WYOMING DEPARTMENT OF ENVIRONMENTAL QUALITY
WATER QUALITY DIVISION
PERMIT TO CONSTRUCT

PERMIT NO. **07-402**

NSU Wastewater System: Phase II – Holding Tanks

REVIEW OF PLANS AND SPECIFICATIONS
WYOMING DEPARTMENT OF ENVIRONMENTAL QUALITY
WATER QUALITY DIVISION

SITE PLAN

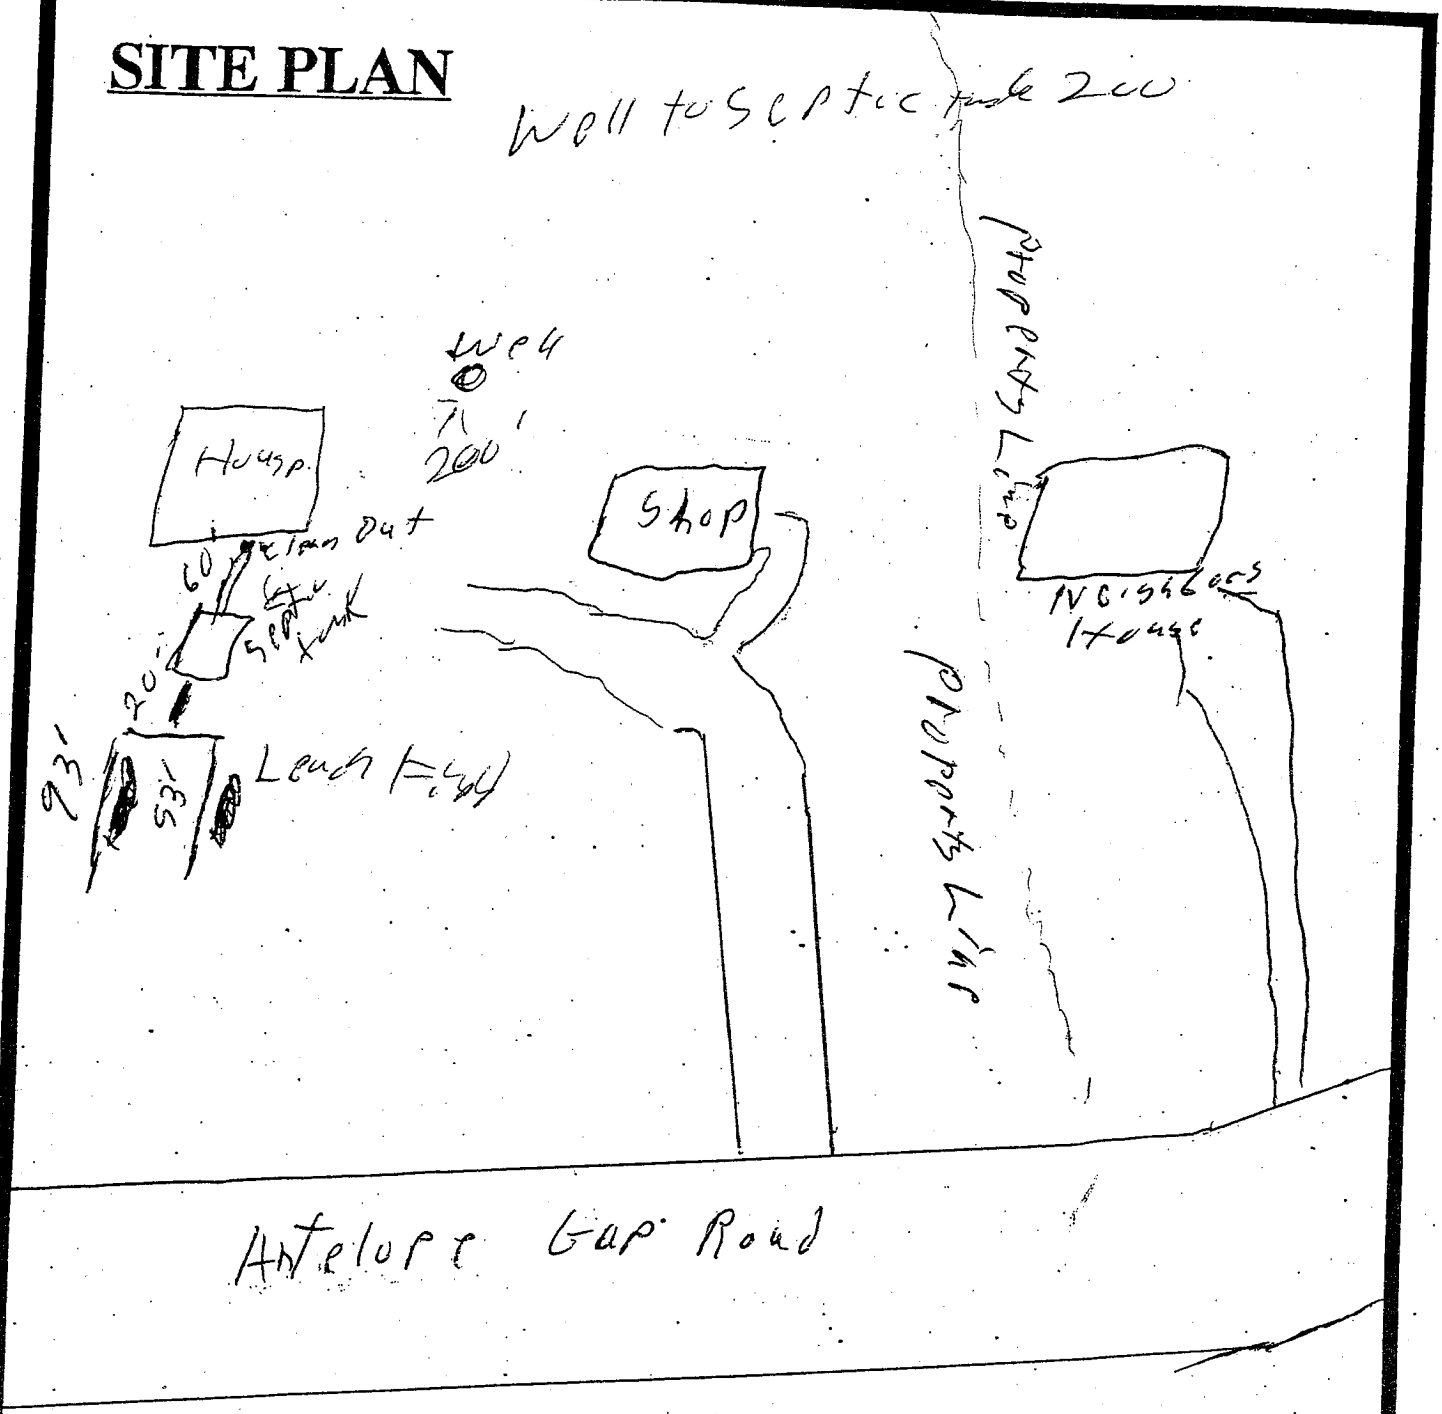
3. Leachfield Site Slope - the application indicates that the ground slope at the location of the leachfield is about 5%. The downhill direction of this slope needs to be shown on the site plan by several small arrows pointed down hill placed on the site plan.

4. Site Plan Inadequacies - the site plan provided is inadequate in several ways. First, Antelope Gap Road runs diagonally from northwest to southeast through the SE¼ of Section 19 (see map included), which is not clear from the site plan provided. Also, North is not indicated on the site plan. Please provide a more accurate site drawing showing the following:
